Tasman District Council

BC190480

Site Address: 31 Pineview Way, Motueka Valley

Project Description: Construct new dwelling and detached sleepout

RAFTER PLAN
1:100

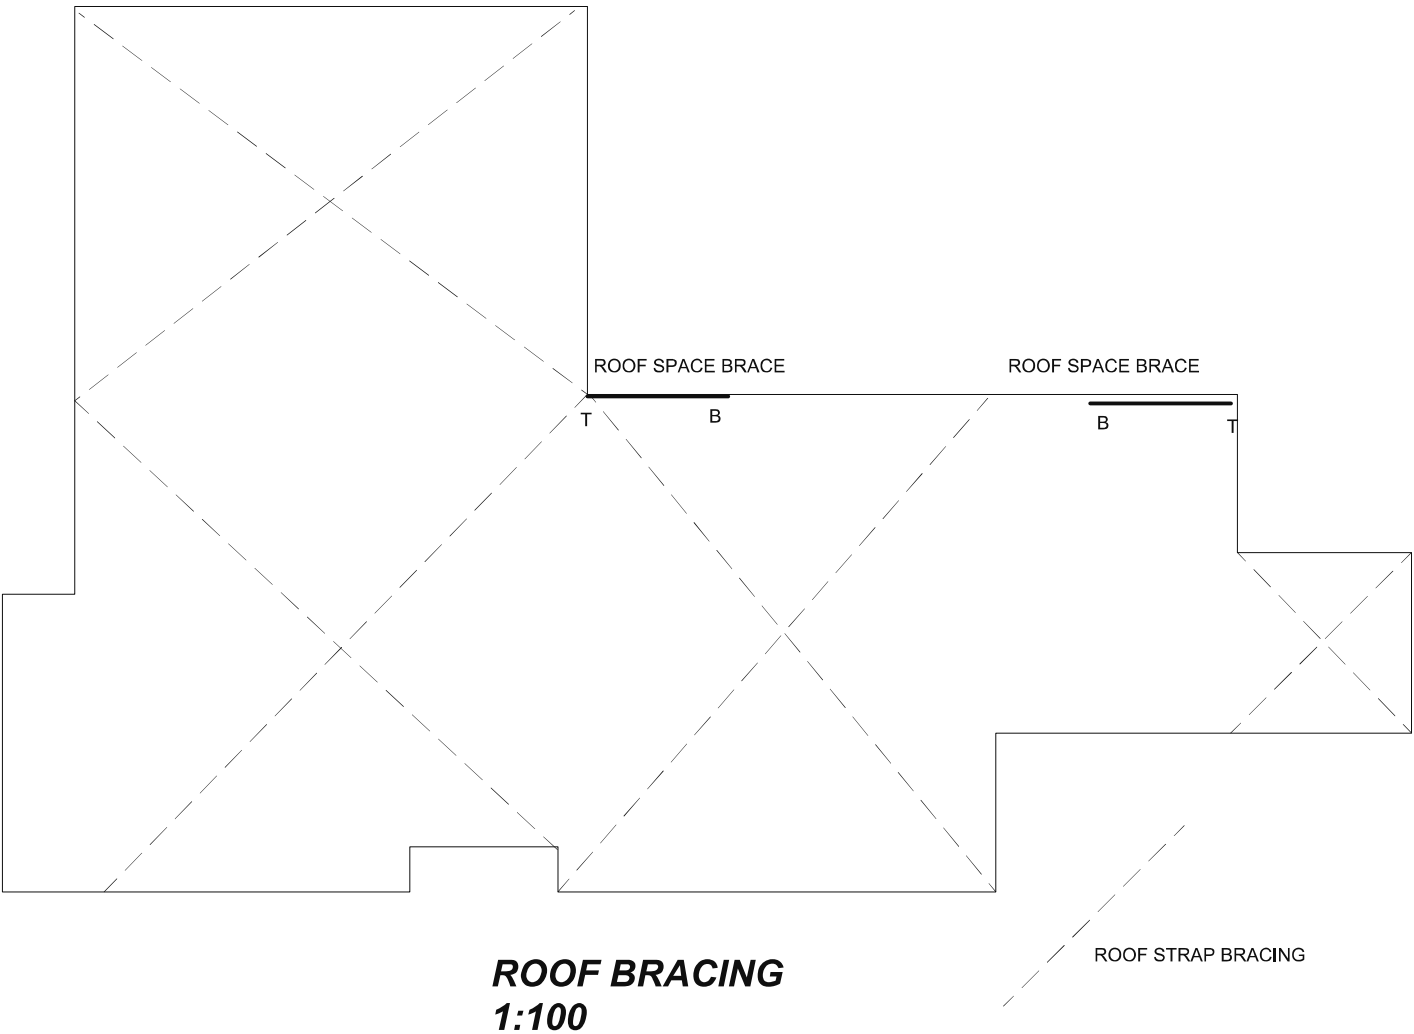
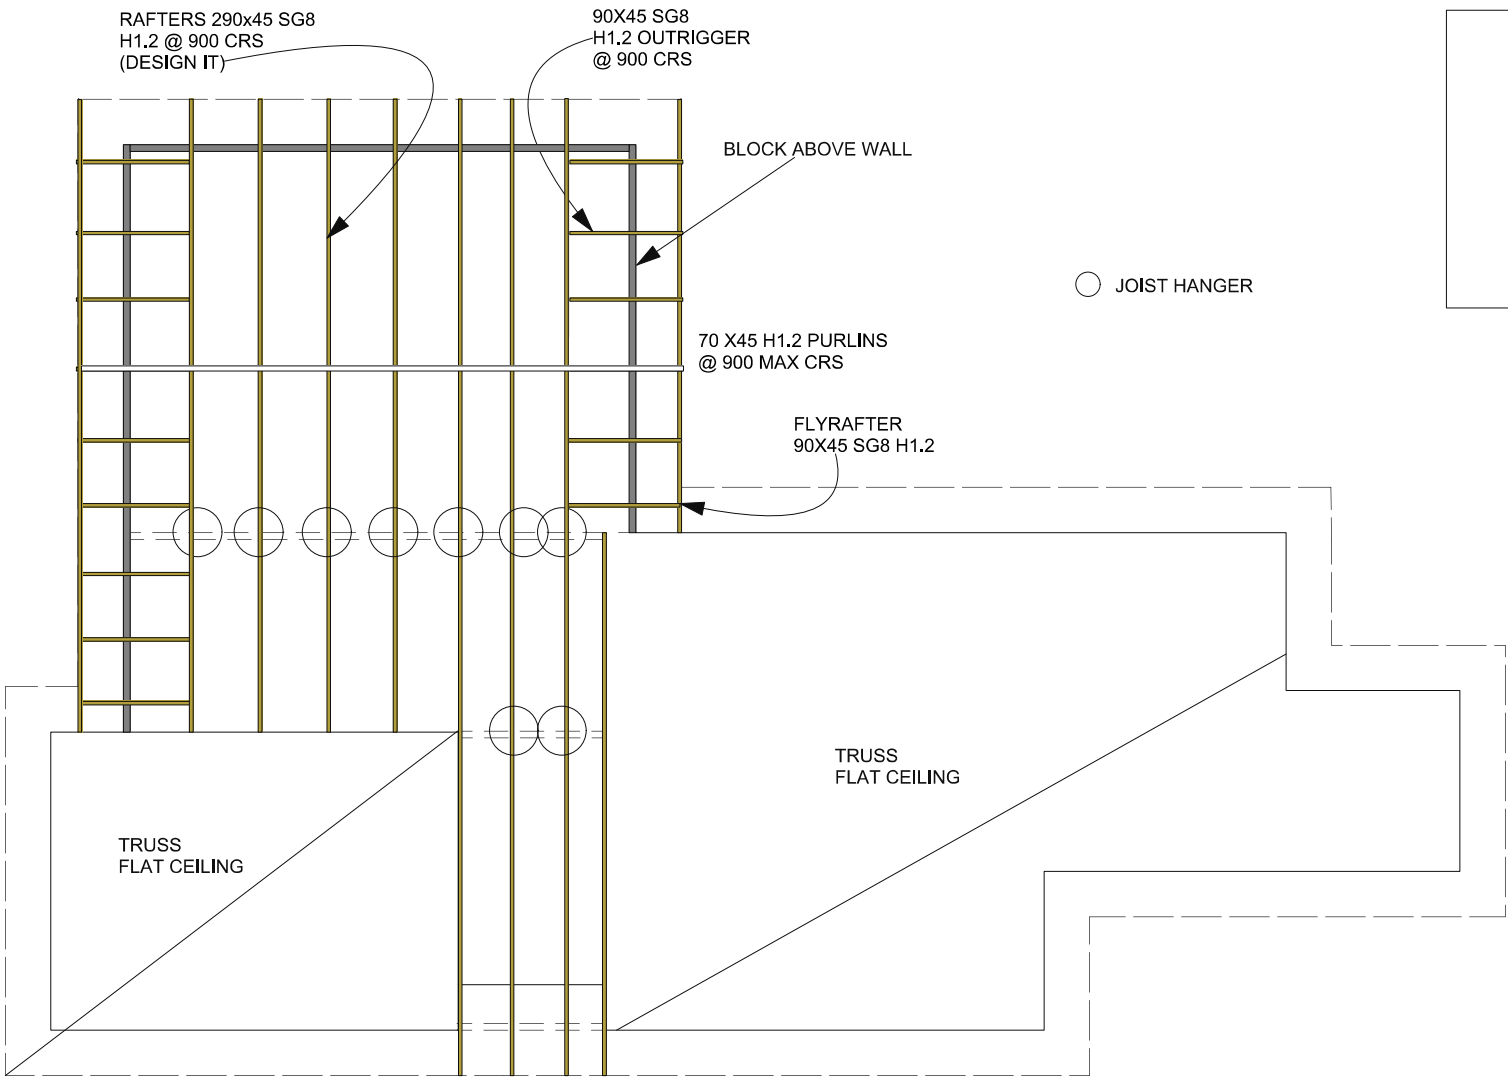
3. Fixing: Does roof frame fixing detailing comply?	Y	BGn	11/06/2019 01:43 pm	Please clarify the proposed fixing of the rafters and the outriggers to the top plate so compliance can be established Resolved - within the RFI response the designer has added a construction note to sheet 9 to establish the required fixing

FIX RAFTERS & OUTRIGGERS TO TOP PLATES
WITH 2/CT200 + 2/100X2.95 SKEW NAILS
